Subject: TCAS 7.1 Installation

Figure 1: TCAS 7.1 Improved Reversal Logic

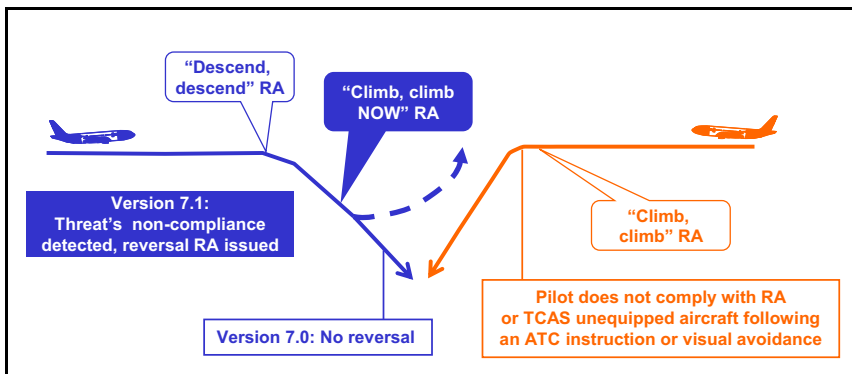
TCAS 7.1 improves reversal logic and allows either aircraft to detect if the other is climbing or descending simultaneously. With this determination, a reversal RA will be issued.

Figure 2: TCAS 7.1 Level Off Alert

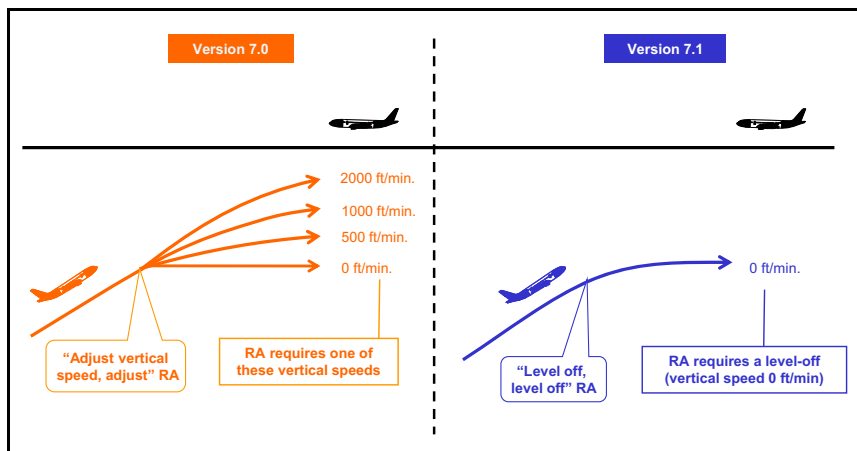
The current “Adjust Vertical Speed” RA directs the crew to reduce vertical speed to 2000, 1000, 500, or 0 fpm. Operational monitoring has revealed that in some cases crews increased their vertical speed instead of reducing it, consequently, causing a deterioration of the situation. TCAS 7.1 replaces several “Adjust Vertical Speed” alerts with a “Level Off” RA. The level off should be achieved promptly, not at the next flight level.
